UNITED STATES
DEPARTMENT OF THE INTERIOR
BUREAU OF LAND MANAGEMENTRECEIVED
OCD ArtesiaFORM APPROVED
OMB NO. 1004-0137
Expires: January 31, 2018**SUNDRY NOTICES AND REPORTS ON WELLS**
Do not use this form for proposals to drill or to re-enter an abandoned well. Use form 3160-3 (APD) for such proposals.

** BLM REVISED ** BLM REVISED ** BLM REVISED ** BLM REVISED ** BLM REVISED **

OXY, USA Inc. - Proposed
Riverbend B Federal #11
API No. 30-015-29320

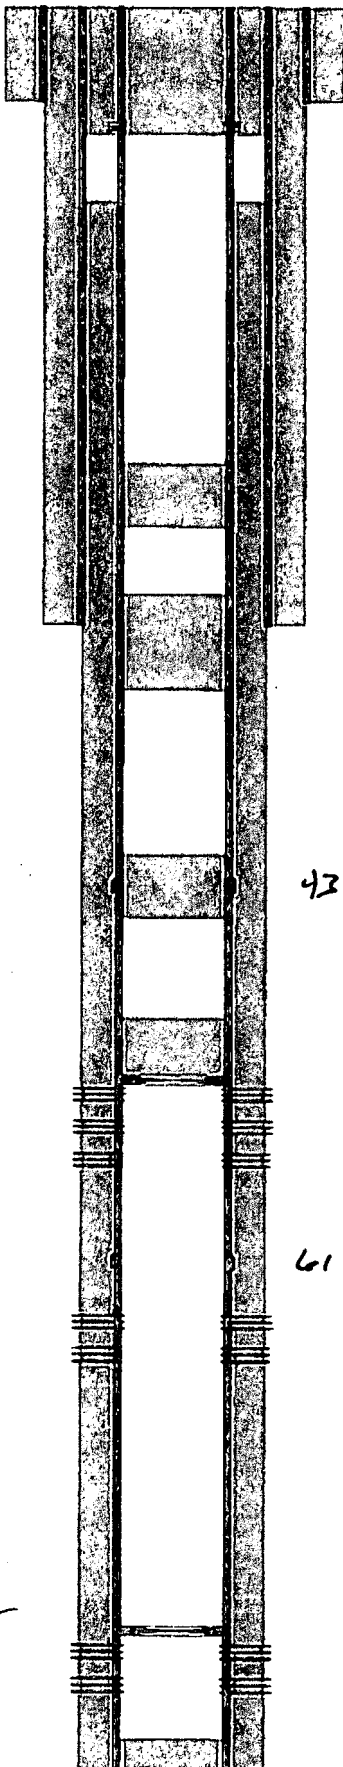
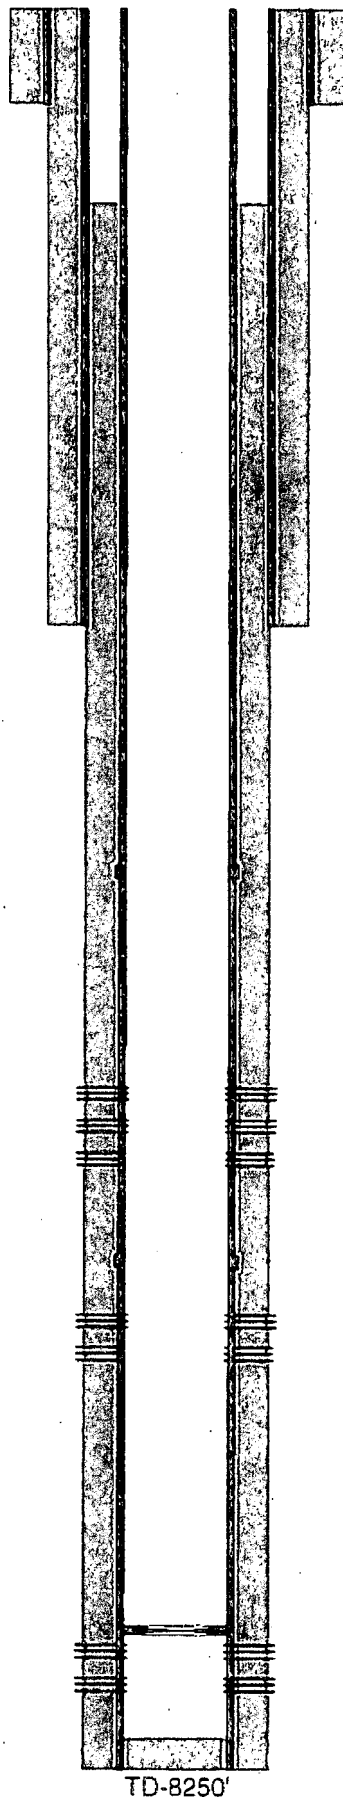
10# MLF between plugs? Above ground steel tanks will be utilized

RIH Tag CIBP @ 7795' Cap w/
35' utilizing Dump Bail or Spot
25 sx. Tag, Spot 25 sx plug
6918 - 6748. woc Tag.
GC 6/26/19
Accepted for record - NMOC (T. Bone Spring)

730 sqz cmt to 485 tag, Perf @ 60 sqz cmt to

Surf or Perf @ 730.502

cmt surf
